SK#43
05 page's
16 **Queries**
Date: 09-09-2025

1250 Maryland Avenue
1250 MARYLAND AVENUE SW
WASHINGTON, DC 20024

DRAWING TITLE
SLAB EDGE - LEVEL 09 TO 10

1 A071 SLAB EDGE - ENLARGED PLAN LEVEL 11
1/4" = 1'-0"

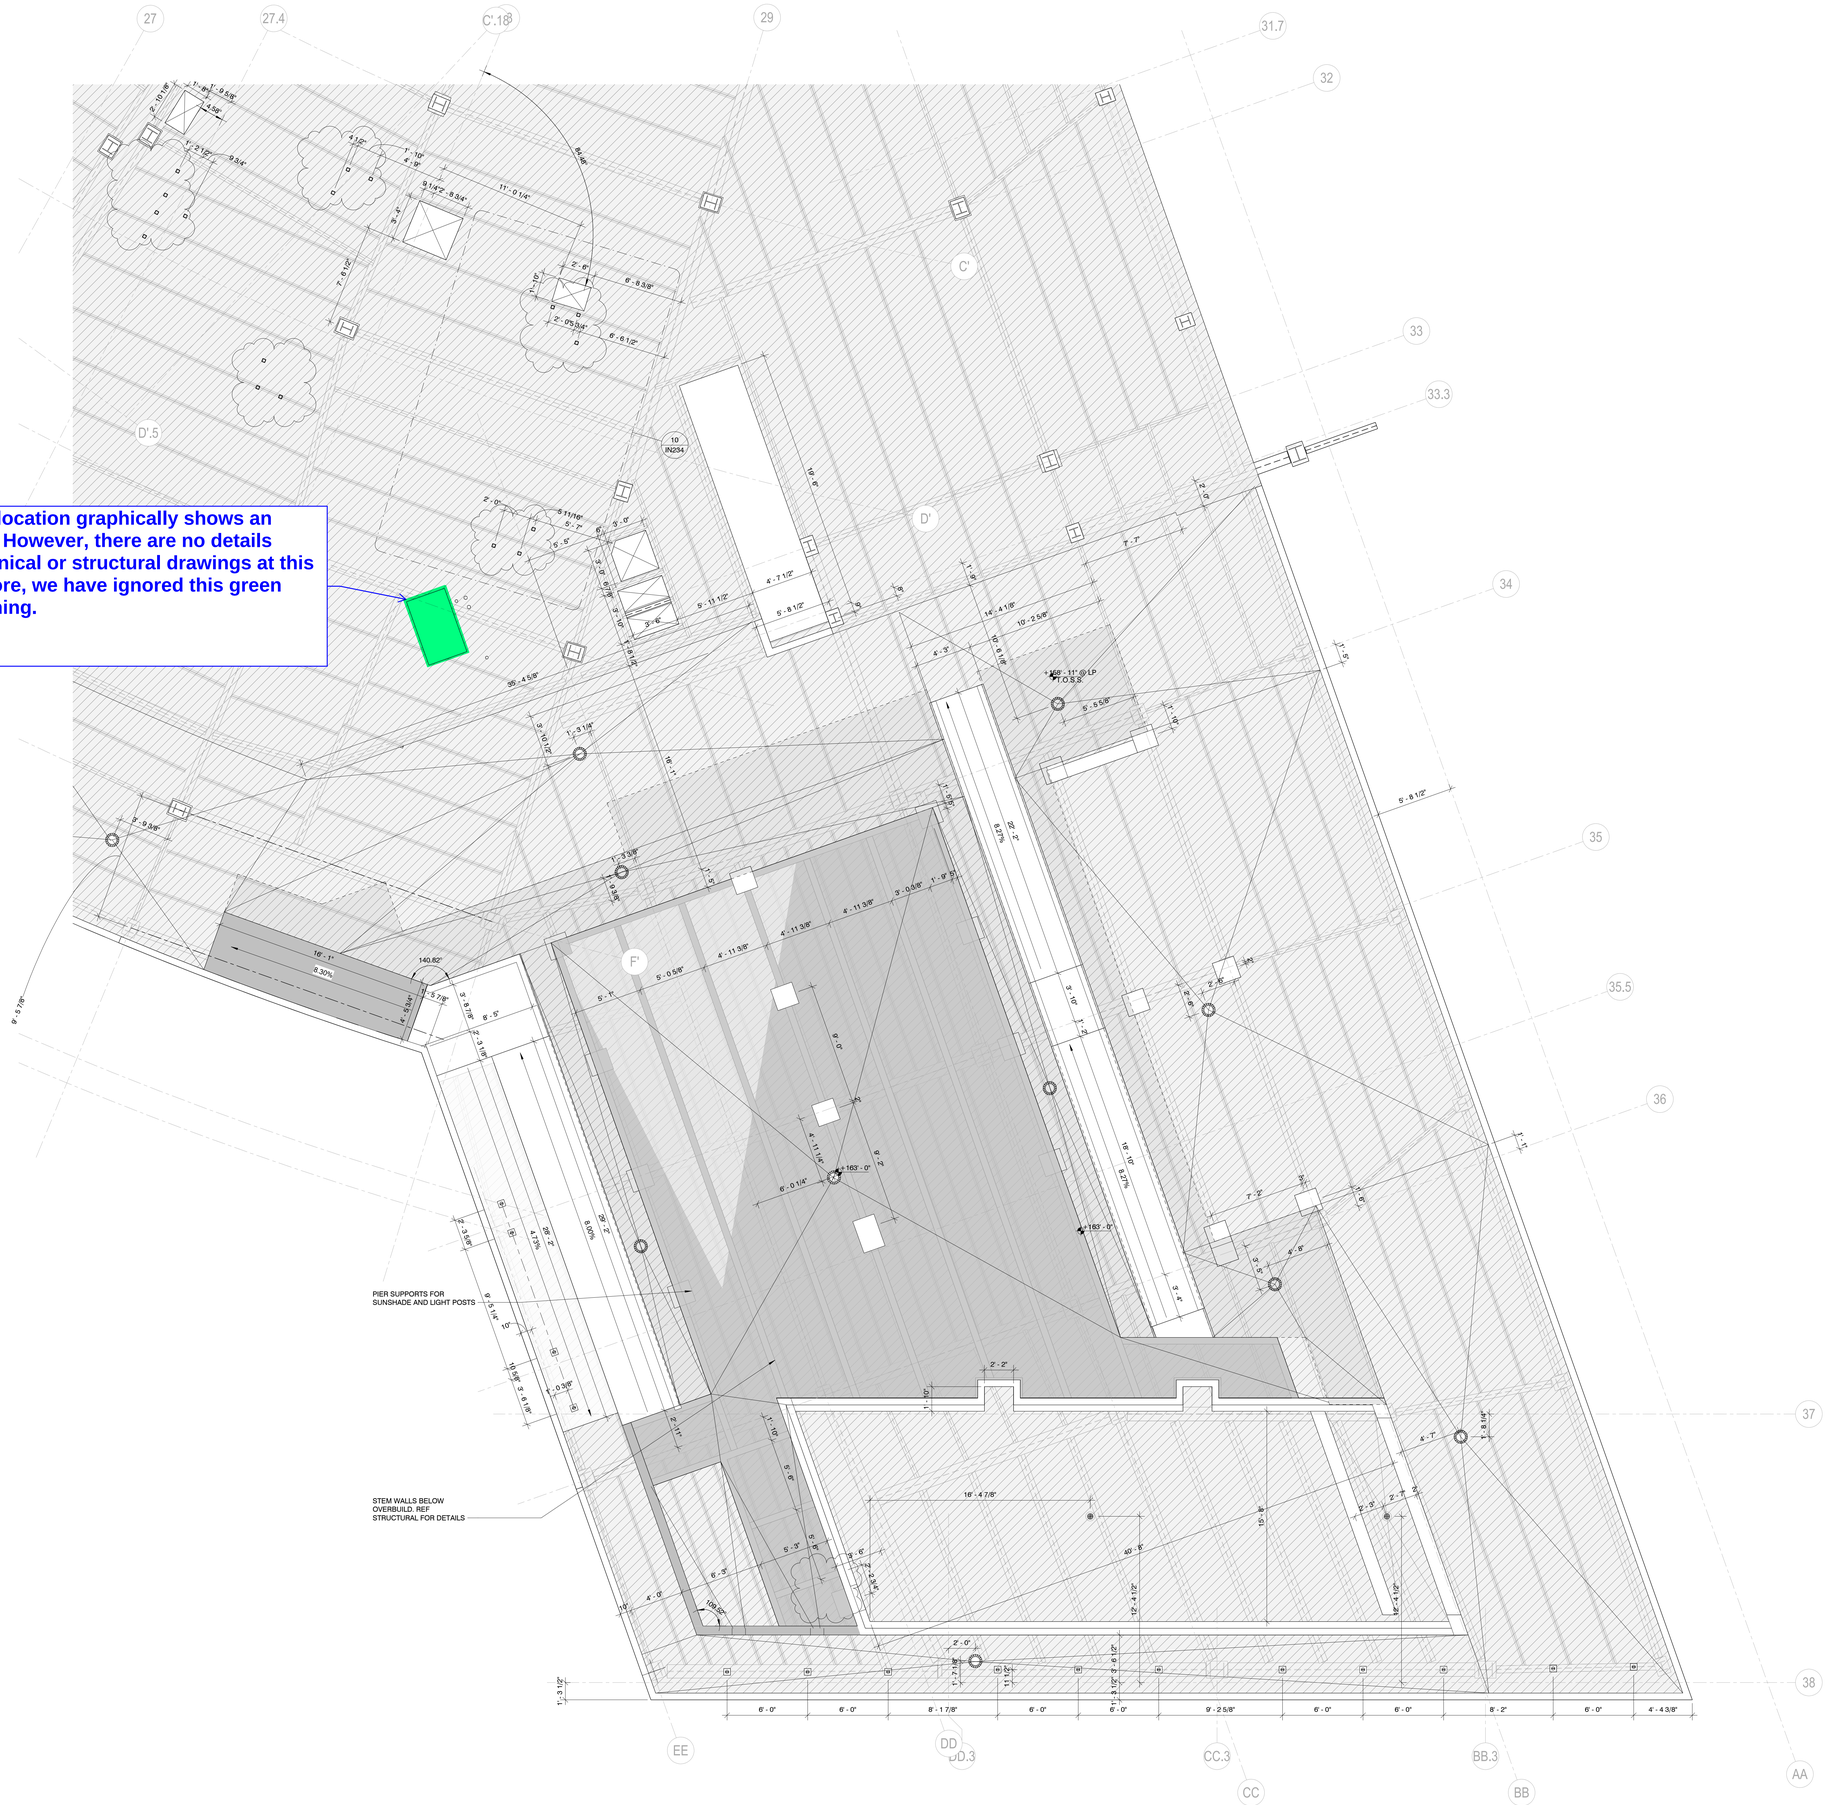
Q6

The highlighted location graphically shows an opening or pad, However, there are no details shown in mechanical or structural drawings at this location. Therefore, we have ignored this green highlighted opening.

Please advise.

16 SLAB EDGE - LEVEL 10-2
A073 1/4" = 1'-0"

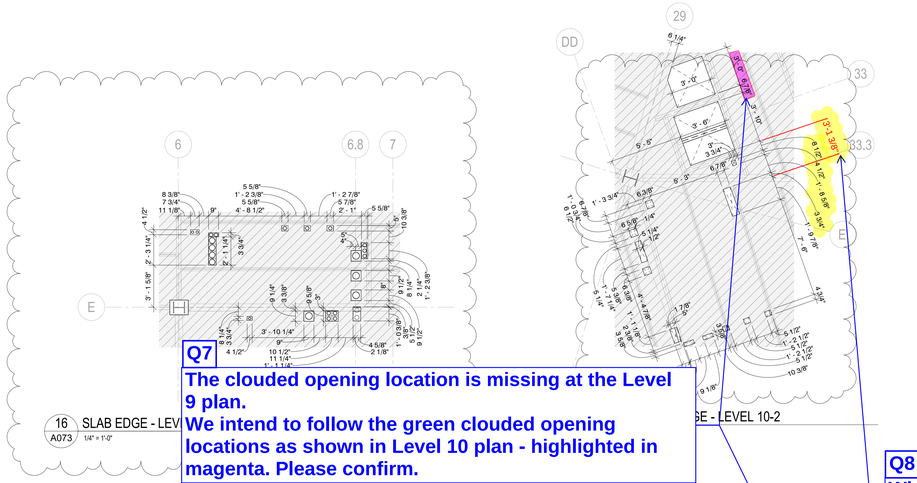
Q7
The clouded opening location is missing at the Level 9 plan.
We intend to follow the green clouded opening locations as shown in Level 10 plan - highlighted in magenta. Please confirm.

Q8
While comparing Level-09 (green highlighted) and Level-10 (yellow highlighted)SUM of opening dimensions from Grid '33.3' shows different values. Therefore, we have followed the Level-09 opening dimension and ignored level-10 dimensions. Please confirm.

SNAP#05 FROM 1-A074 - LEVEL-11

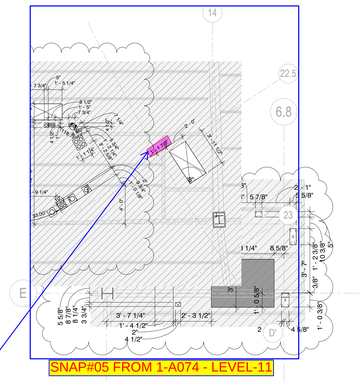
Q9
We intend to use the magenta highlighted dimension(shown in Level-11) for the level 9 & level10 since the level 9 & 10 plans doesn't shows the same.

Q10
Please provide the missing ('?') dimension

4 SLAB EDGE - ROOF - Callout 3
A074 1/4" = 1'-0"

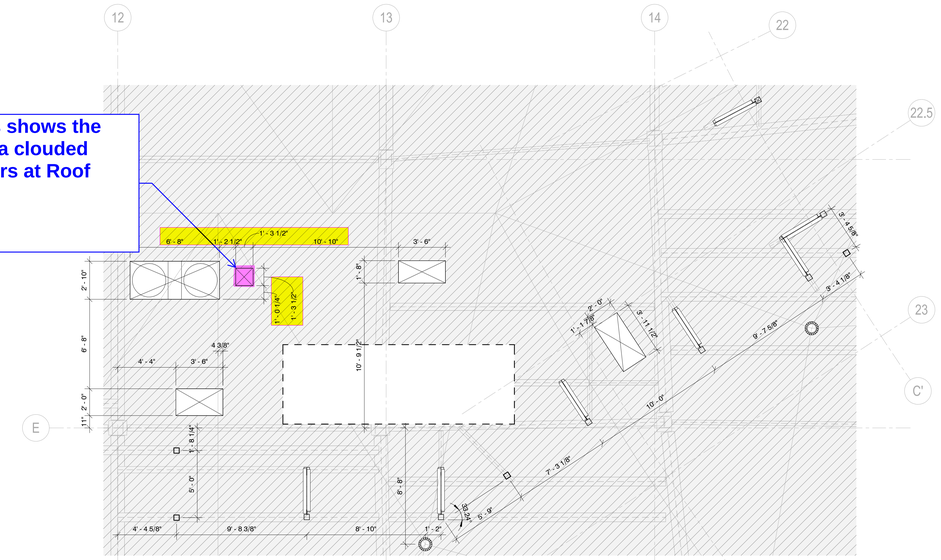
Q11

From level-9 thru level 11, Plan drawings shows the same locating dimension for the magenta clouded opening but the locating dimension differs at Roof level.

please advise.

10 ENLARGED SLAB EDGE - LEVEL 9 -2 (LEVEL 10 SIM)
A073 1/4" = 1'-0"

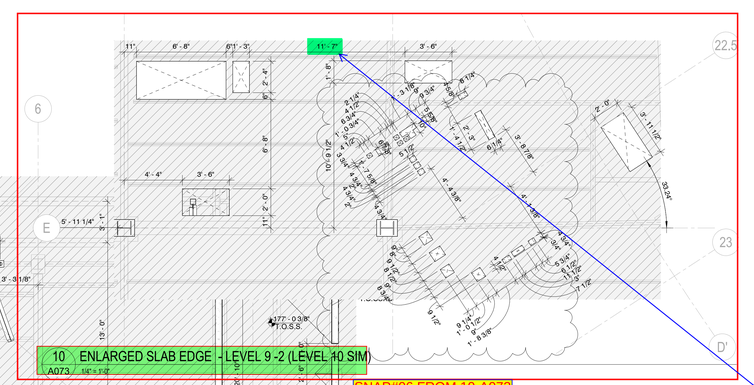
Q12

We intend to move the cyan highlighted beam 1" towards SOUTH to clear the magenta opening. Please confirm.

2 SLAB EDGE - ROOF - Callout 1
A074 1/4" = 1'-0"

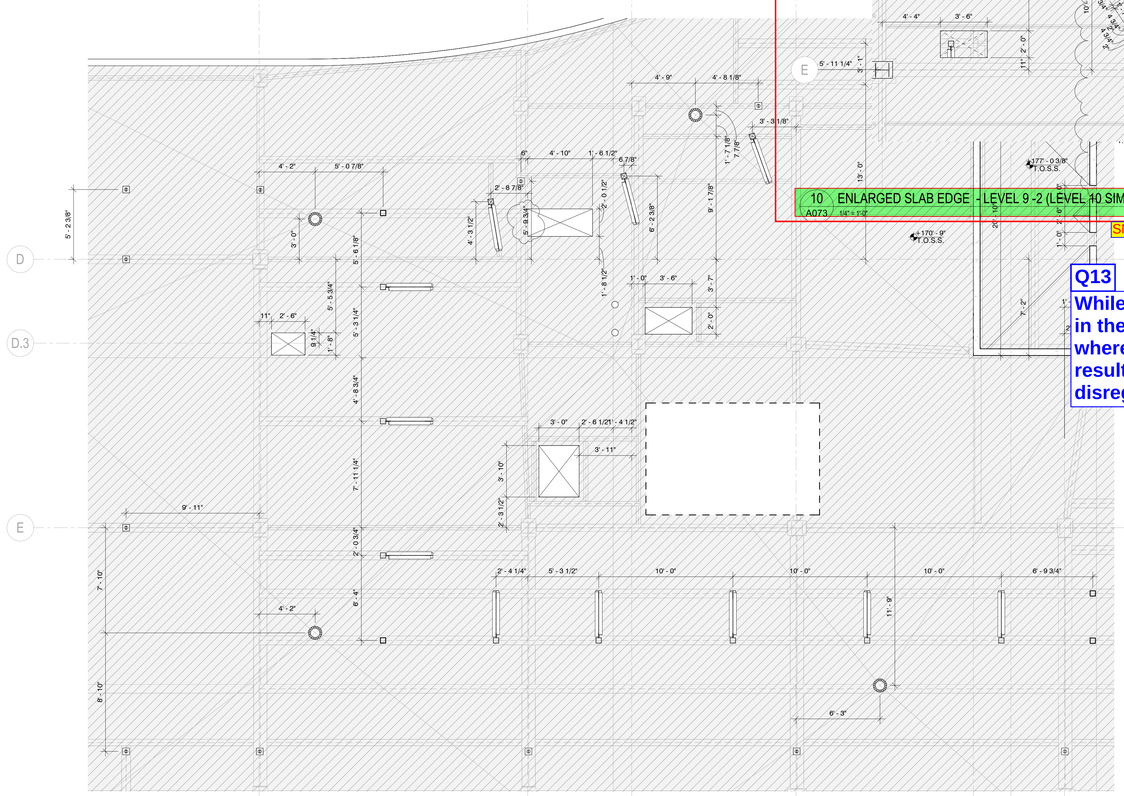
Q13

While adding the clouded dimension, we observed a conflict in the opening location. Level 9 shows 11'-7"(see snap#06), whereas the yellow clouded area reflects 11'-7 1/8", resulting in a 1/8" discrepancy. Please confirm if we should disregard the variation and follow the Level 9 dimension?
